Ademco Inc. is seeking a Class 2 permissive change under FCC 15.247 for a Wifi Duo

Thermostat under FCC ID: HS9-TH8321WF01

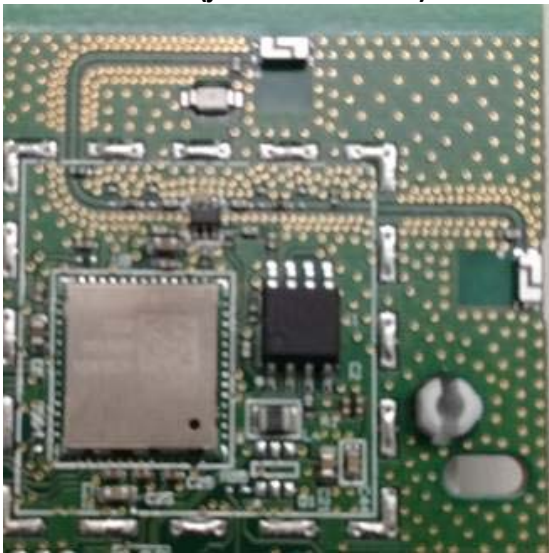
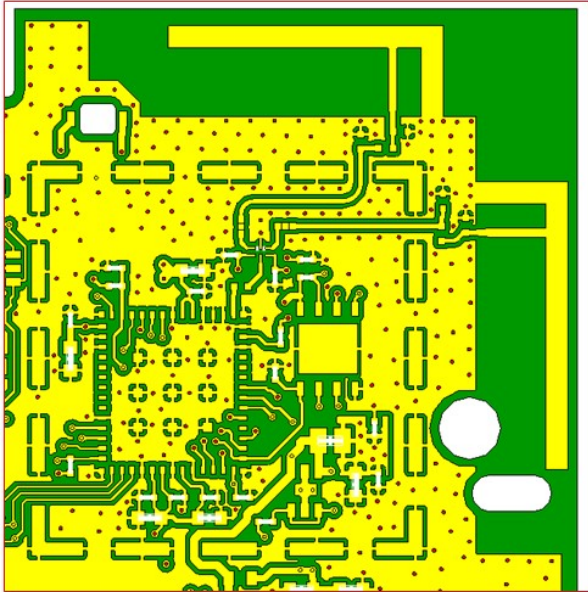
The actual product has two PCB's and the new product will just have one.

The important change being that the current antennas (two) in the product are chip antennas and the new one will be printed in the PCB (The product uses 2 antennas for diversity. Only one antenna used at any time (single stream). Both antennas are standard PIFA antennas etched on the PWB).
